Project number: 20004
Prepared by: Helen Jenkins/Andy Roberts
Subject: Comments on proposed development at land off Capel Street, Capel-le-Ferne
Date: 15th January 2020 **File no:** 20004.D1a

1.1.1 This technical note has been produced on behalf of Capel-le-Ferne Parish Council to comment on the proposals for 34 residential dwellings off Capel Street (between Nos. 107 to 127). Lime Transport's experience and the qualifications of this report's authors are included at the back of the report.

Figure 1 Extract from Amended Proposed Highway Works drawing

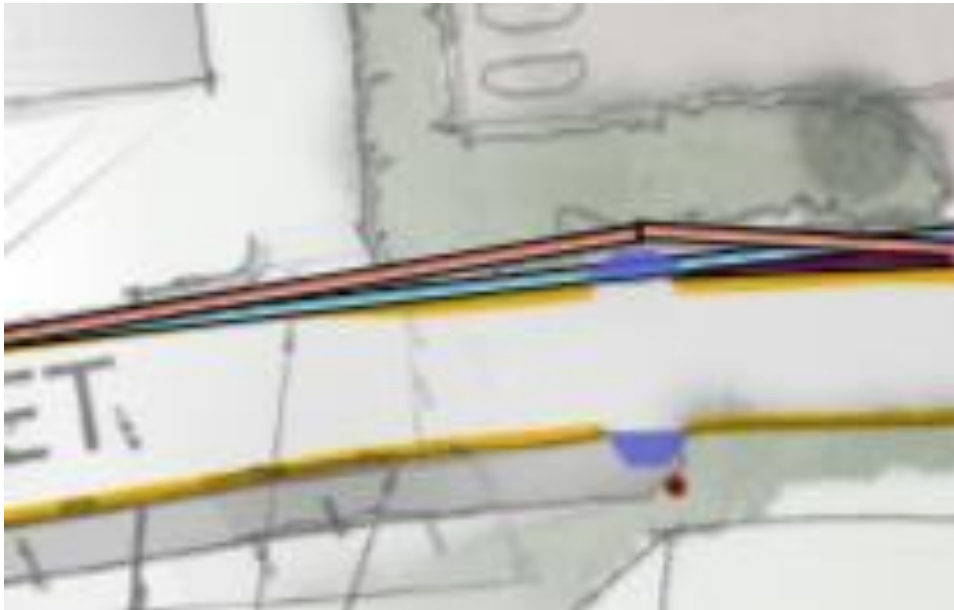
- 2.9.2 The submitted drawing is not acceptable as:
- It does not show a number of existing accesses to private driveways.
 - It is not possible to determine how the carriageway of Capel Street is being widened from 4.2-5.1m to 5.5m. There is no key to show the extent of existing carriageway or the proposed widening and whether this is to the eastern or western side of the existing carriageway.

- The width of the visibility splay lines obstructs the base plan and makes assessment of the impact on third party land difficult. An extract (Figure 1) showing pedestrian visibility splays appearing to cross private land (No. 107) is included below.

Drawing Status	Date 14.01.2020
PRELIMINARY	Scale 1:100@A1
Project	Drawn ABR
Land at Capel Street, Capel-Le-Ferne	Checked HLJ
	Project No 20004
Title	Client Project No
Swept-path analysis - large refuse vehicle leaving the site and heading north	Revision
Drawing No 20004.TOPO.101.02

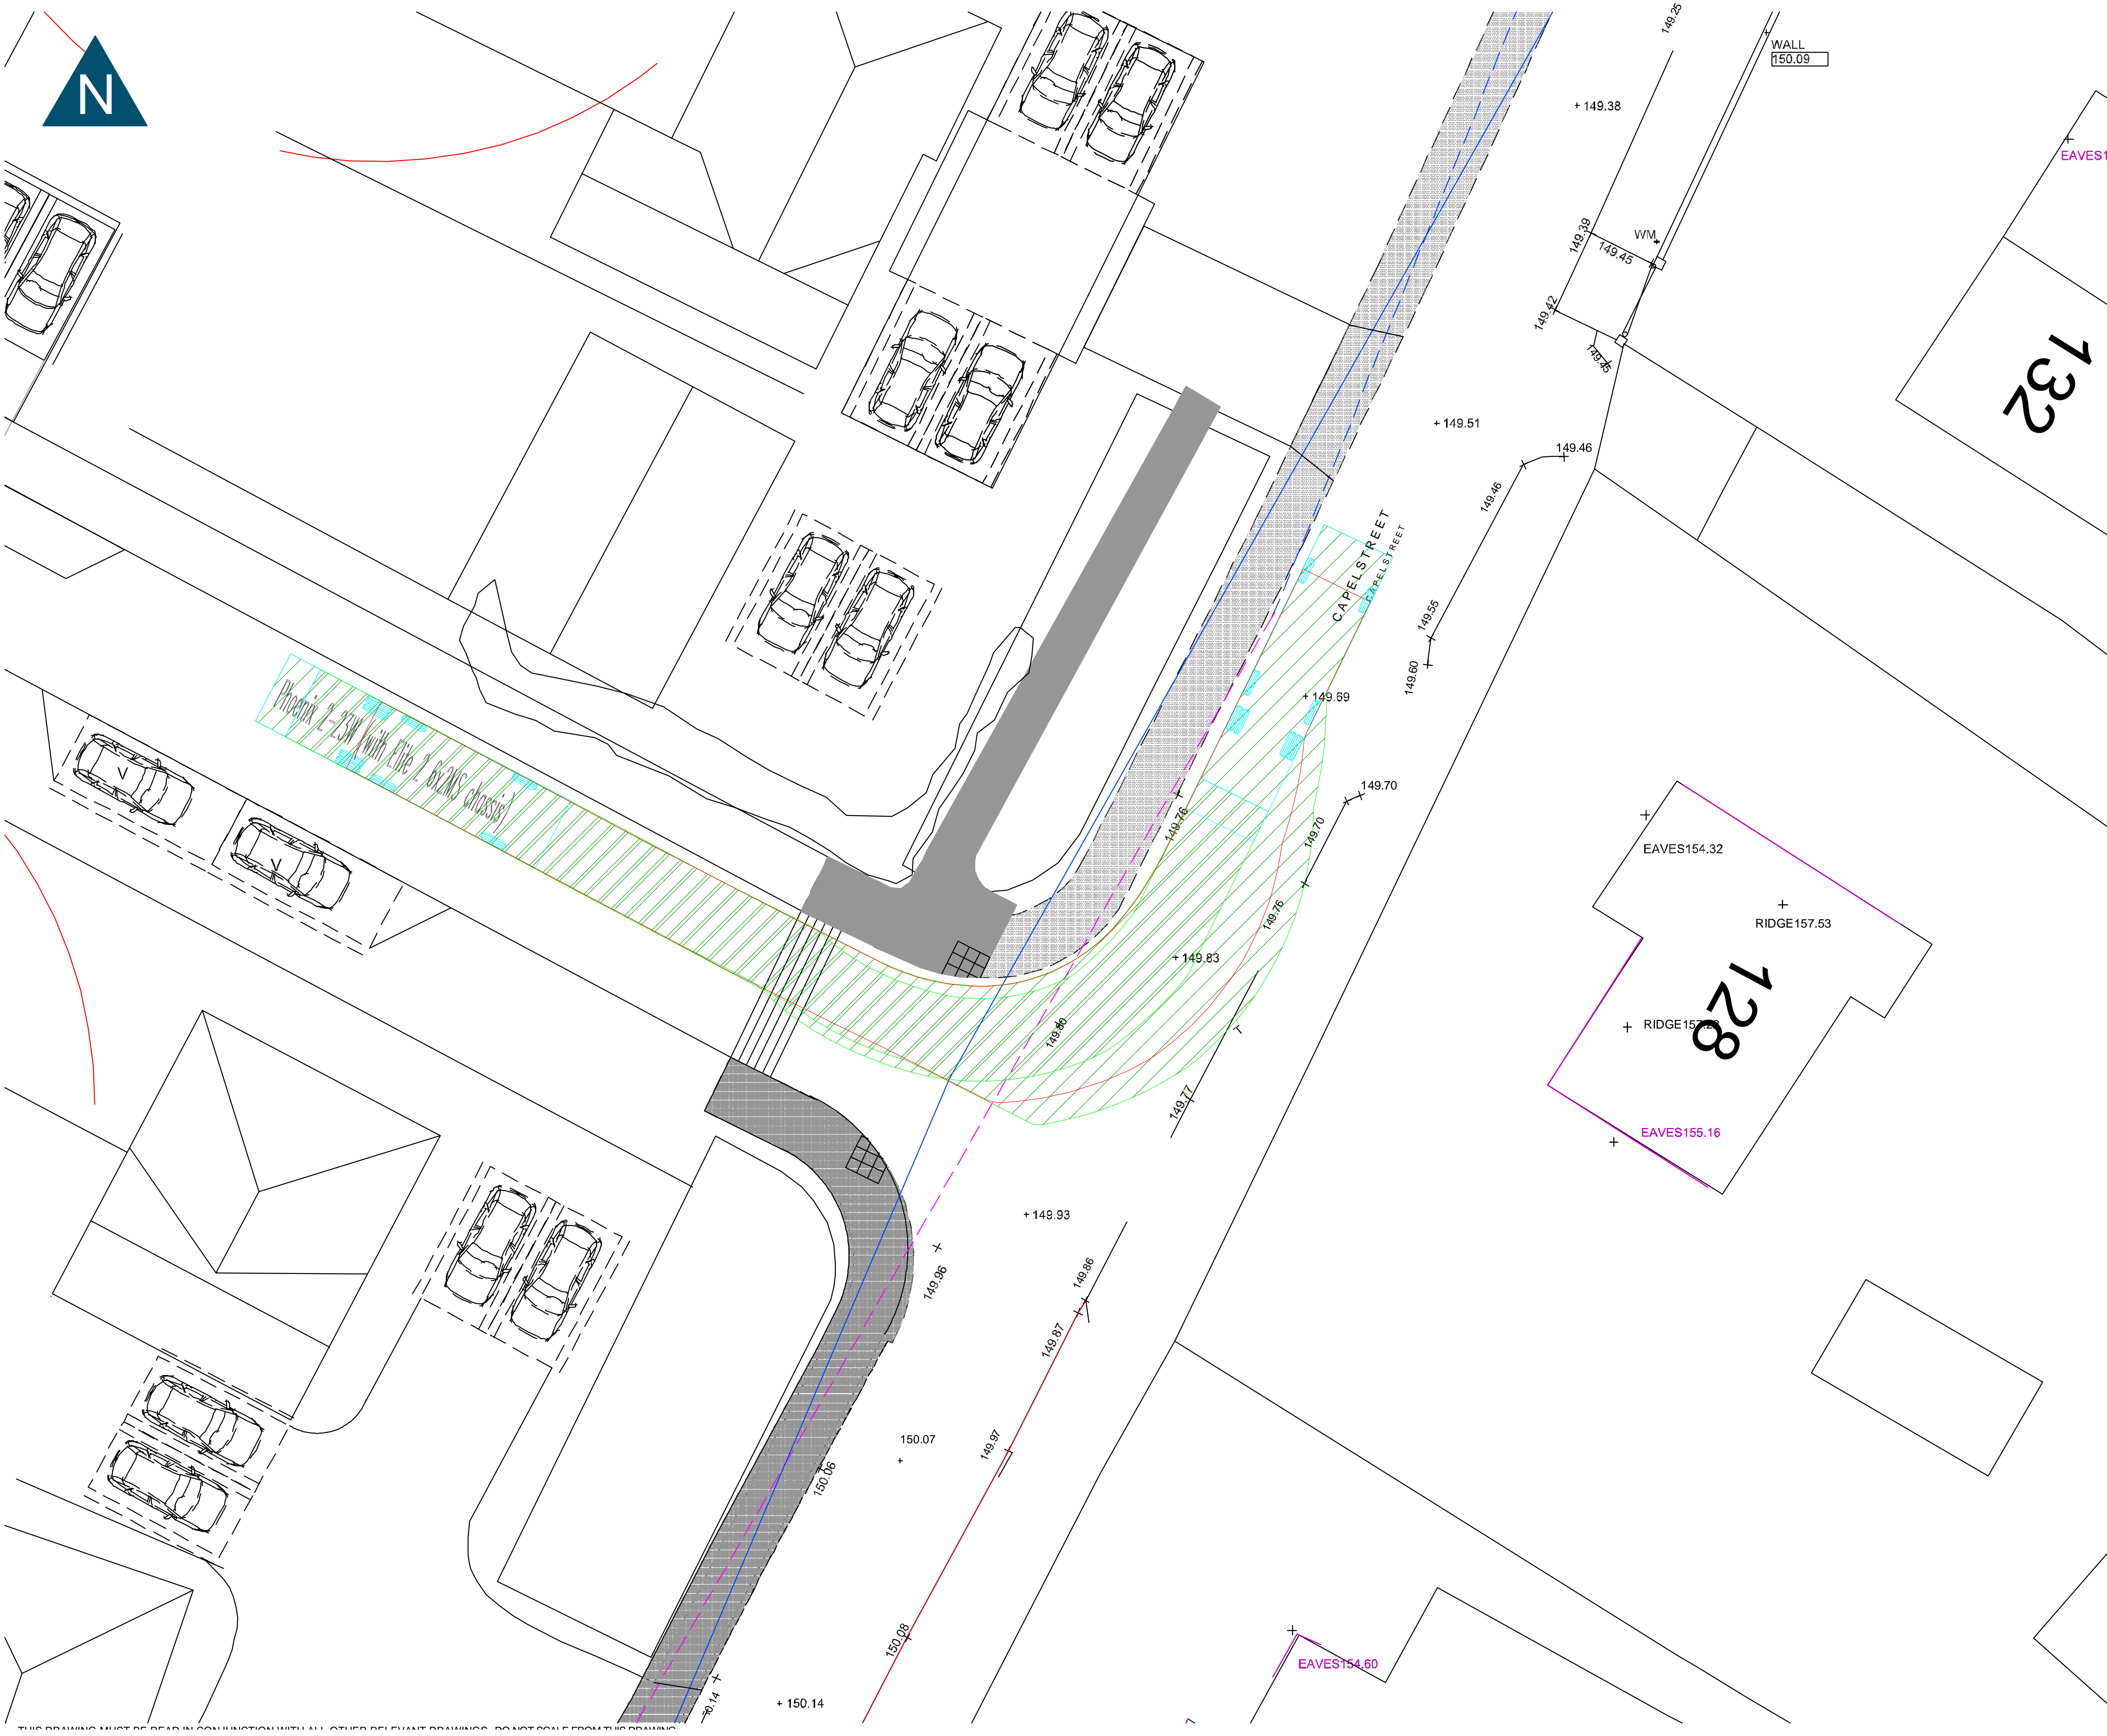
- There is no swept-path analysis to demonstrate that a large refuse vehicle can egress the site without over-sweeping the centre-line of Capel Street in to the path of an oncoming vehicle. Again, swept-path analysis has been carried out as part of this review, which demonstrates that the body of the vehicle will over-sweep the entire carriageway and even the verge on the eastern side of Capel Street (see drawing 20004.TOPO.101.02).

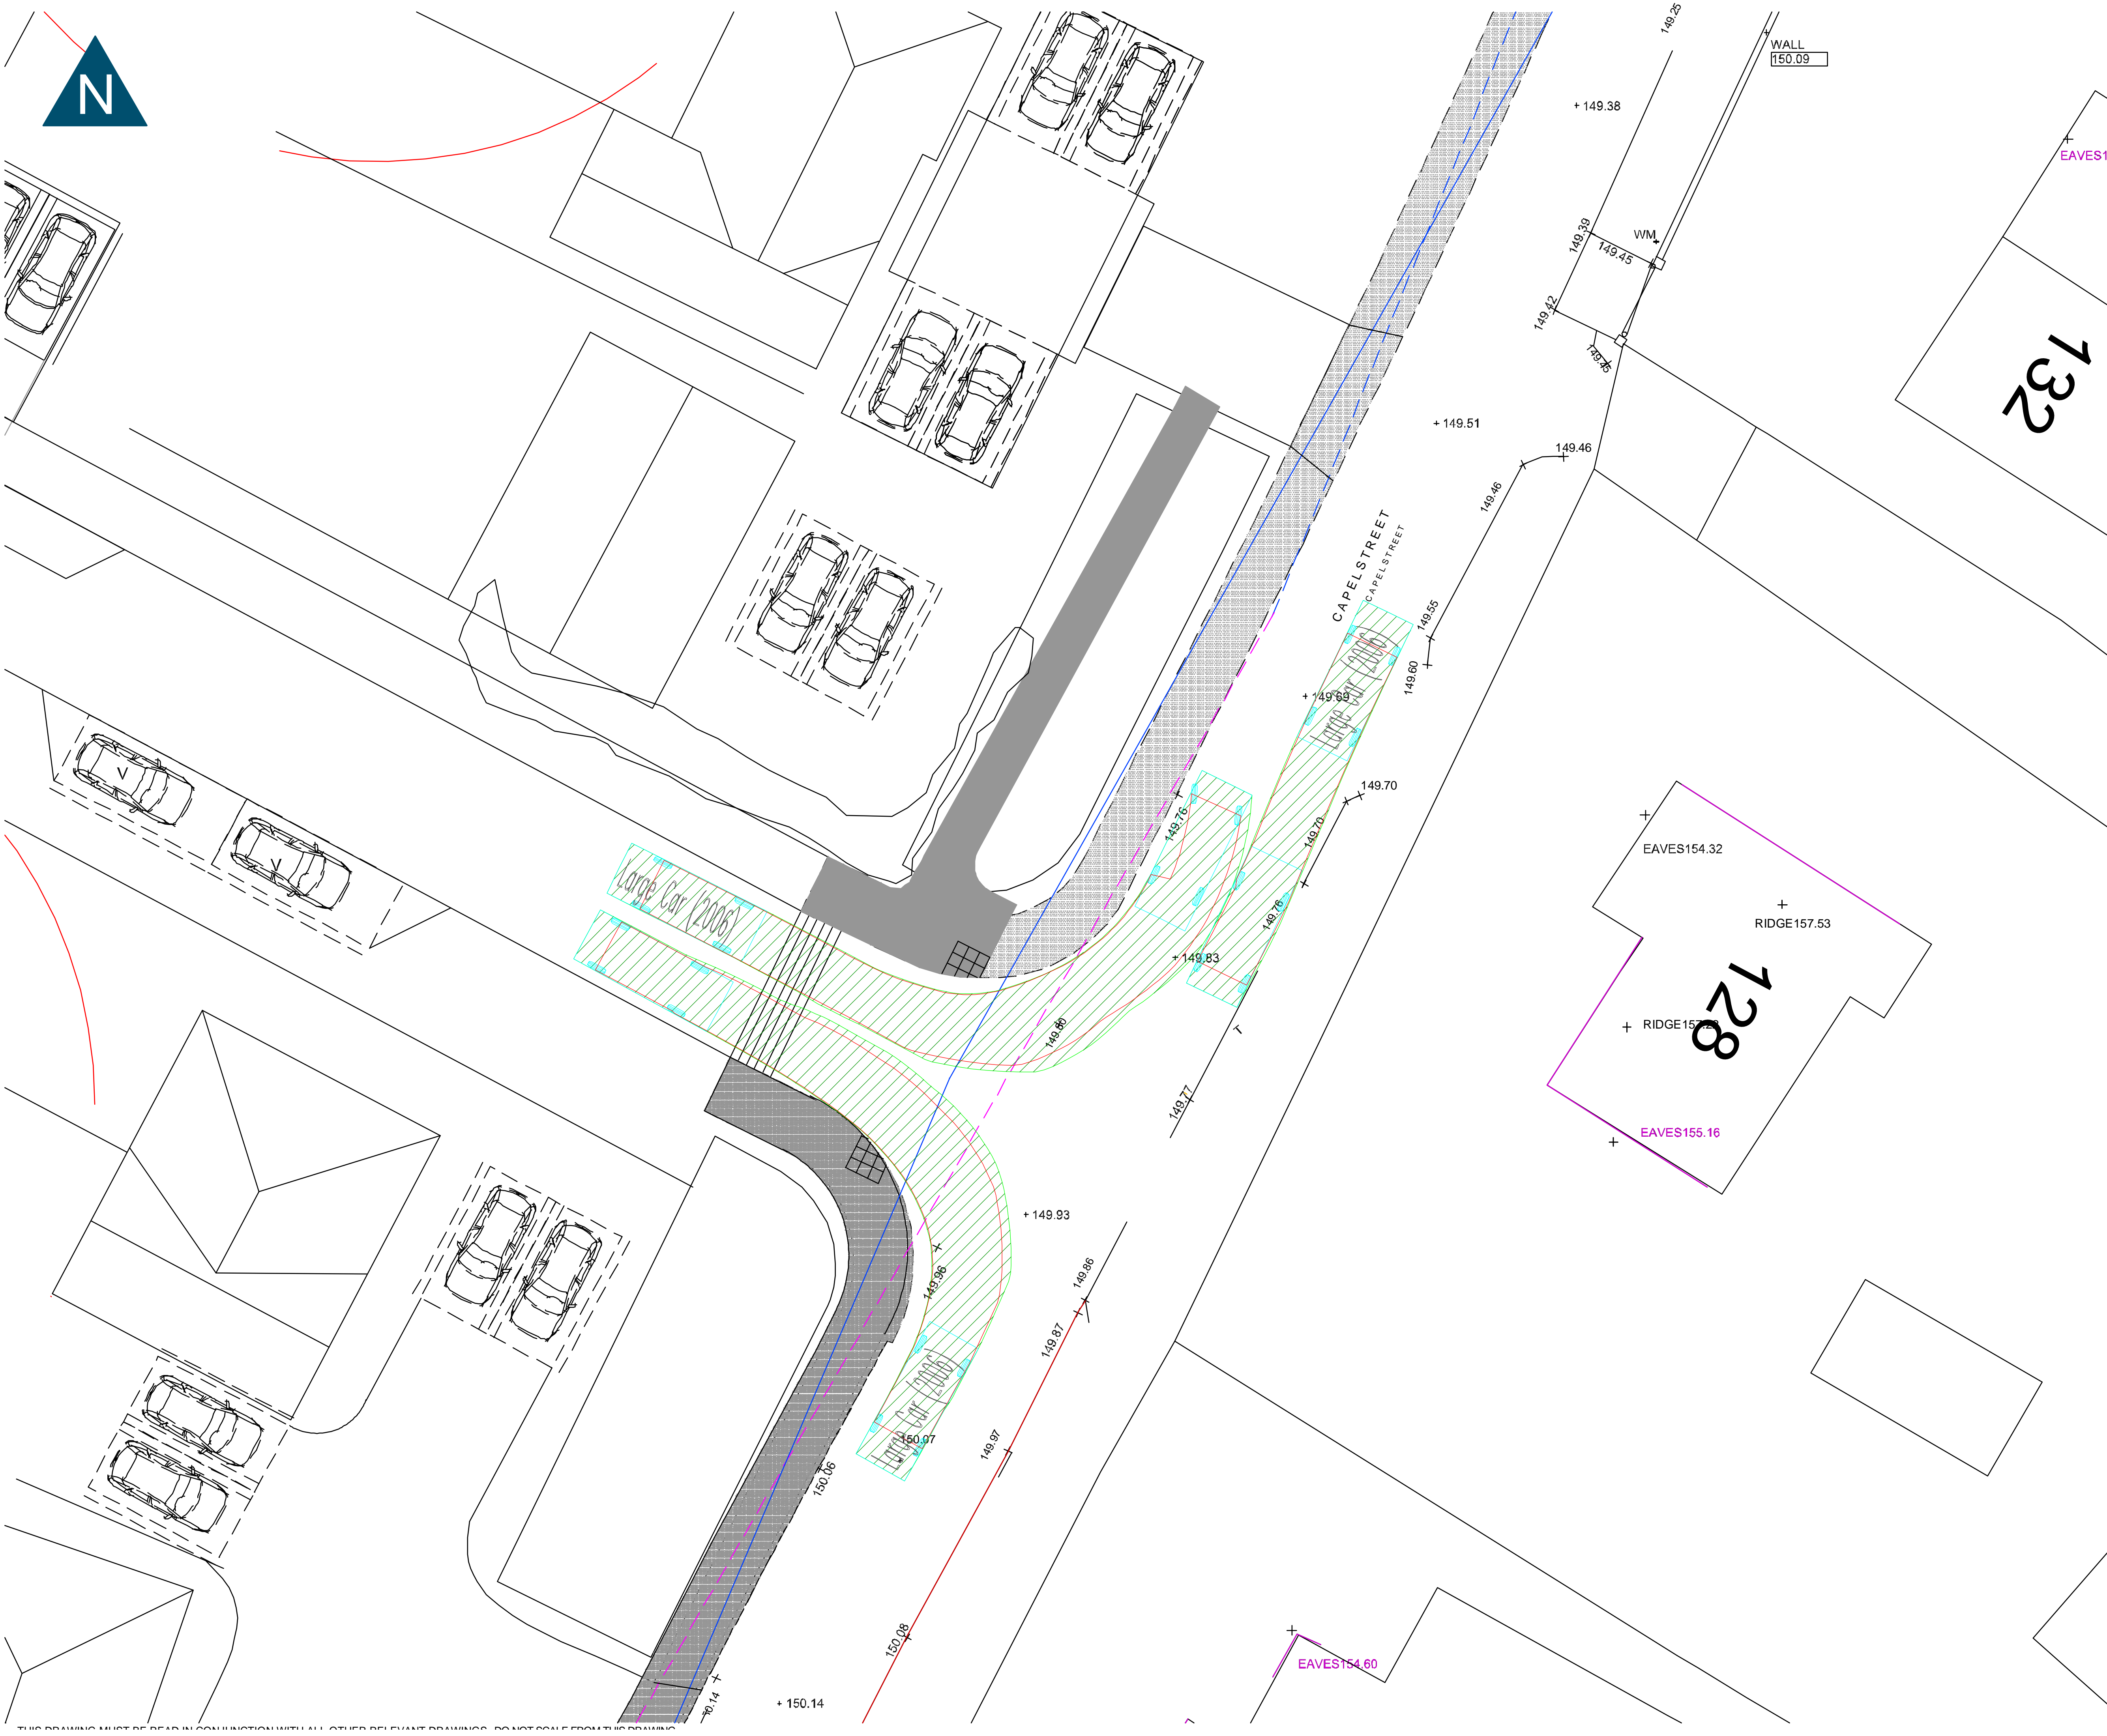
- There is no swept-path analysis to demonstrate that a large car can egress the site without over-sweeping the centre-line of Capel Street into the path of an oncoming vehicle. As part of this review, swept-path analysis has been undertaken. This shows that a large car turning left out of the site, will cross the centre-line of Capel Street potentially into the path of an on-coming vehicle (see drawing 20004.TOPO.101.03).
